Proposed Area Navigation Standard Instrument Departure Procedures at Phoenix Sky Harbor International Airport

Project Description

Proposed Departure Routes with 2014 and 2017 Departure Tracks

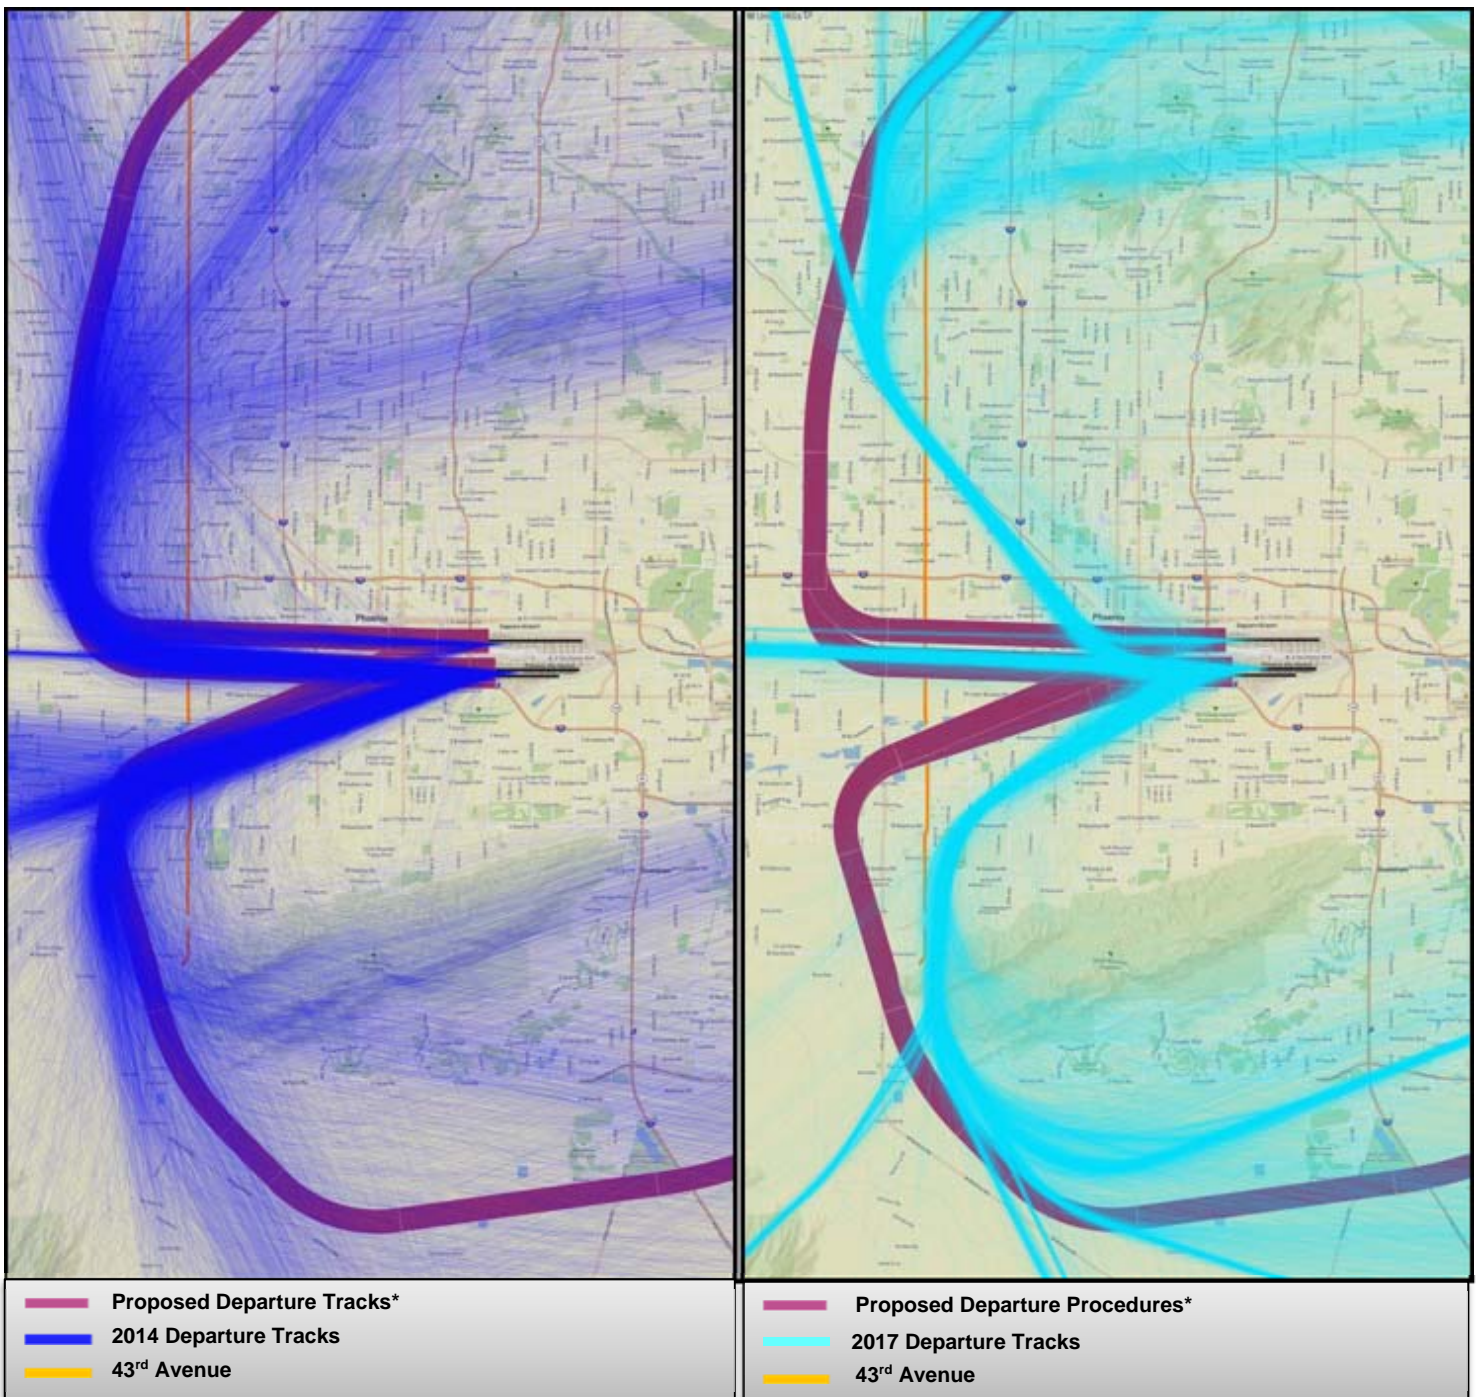
ZEPER RNAV SID heads northwest and will retain Step One A runway transitions. The ZEPER RNAV SID will replace MAYSA RNAV SID.

QUAKY RNAV SID heads north, and will retain Step One A runway transitions. The QUAKY RNAV SID will replace SNOBL RNAV SID.

MRBIL RNAV SID heads north until it intersects the YOTES fix, at which point it splits into three transitions. It will retain Step One A runway transitions. The MRBIL RNAV SID will replace YOTES RNAV SID.

FORPE RNAV SID heads northeast. It will retain Step One A runway transitions. The FORPE RNAV SID will replace LALUZ RNAV SID.

BROAK RNAV SID heads east. It will retain Step One A runway transitions. The BROAK RNAV SID will replace FTHLS RNAV SID.

ECLPS RNAV SID heads southwest. It will retain Step One A runway transitions. The ECLPS RNAV SID will replace KATMN RNAV SID.

STRRM RNAV SID heads south. It will retain Step One A runway transitions. The STRRM RNAV SID will replace BNYRD RNAV SID.

FYRBD RNAV SID heads southwest. It will retain Step One A runway transitions. The FYRBD RNAV SID will replace JUDTH RNAV SID.

KEENS RNAV SID heads west. It will be implemented in Step One A to replace the westbound transitions on the IZZZO RNAV SID, and amended to include eastbound transitions in Step 1B. It will retain same name.
